Designation: **F 1761 – 9600**

## Standard Test Method for Pass Through Flux of Circular Magnetic Sputtering Targets<sup>1</sup>

**FIG. 1 PTF Test Fixture Setup Schematic Drawing**

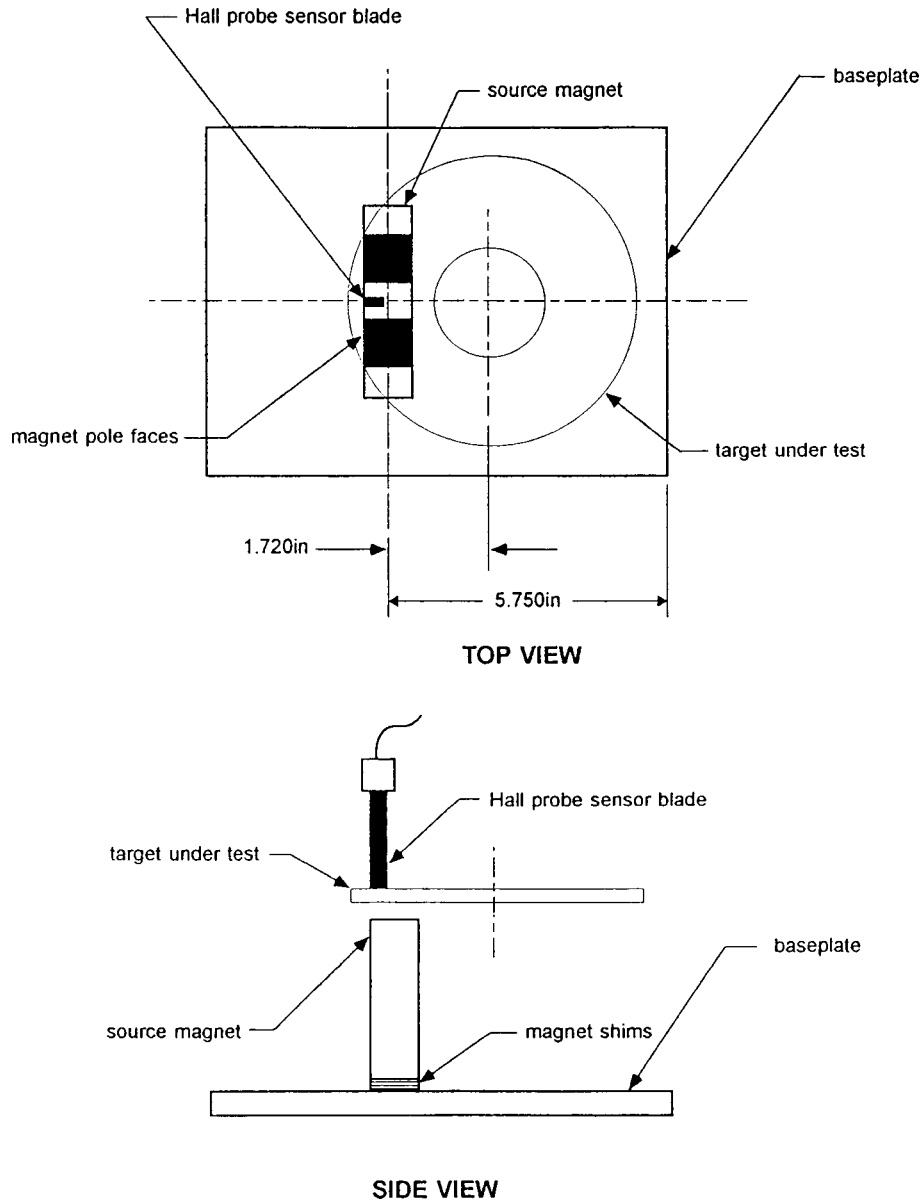
~~7.1 Verify that the source magnet is securely clamped with its vertical center plane located  $5.750 \pm 0.015$  in. ( $146.1 \pm 0.4$  mm) from the end of the baseplate. This arrangement is illustrated in Fig. 1–F~~

~~7.5 By visual sighting, align the cross arm collar to maintain this height. Swing (rotate) the cross arm as required to place the Hall probe half way between the poles of the source magnet. These arrangements are illustrated as indicated in Fig. 1. Tighten 1, but with the nylon friction screws probe tip close to secure but not touching the probe position.~~

~~7.6 Rotate the target support table. The Hall probe support tube in its cross arm clamp to orient should be roughly centered between the Gaussmeter probe blade transverse to magnet poles, and the source field. That is, the flat faces flats of the Hall probe blade must should be in a vertical plane that also contains parallel to the fixture baseplate's fixture's long dimension centerline; this alignment is illustrated in Fig. 1.~~

~~7.7 Note dimension. Note that the location of the Hall probe tip. The outer vertical edge of the probe blade should be is aligned with the edge side of the source magnet, as illustrated in Fig. 1. Loosen the post attachment screw at the baseplate and adjust the Hall probe post position, if necessary, to achieve the correct location.~~
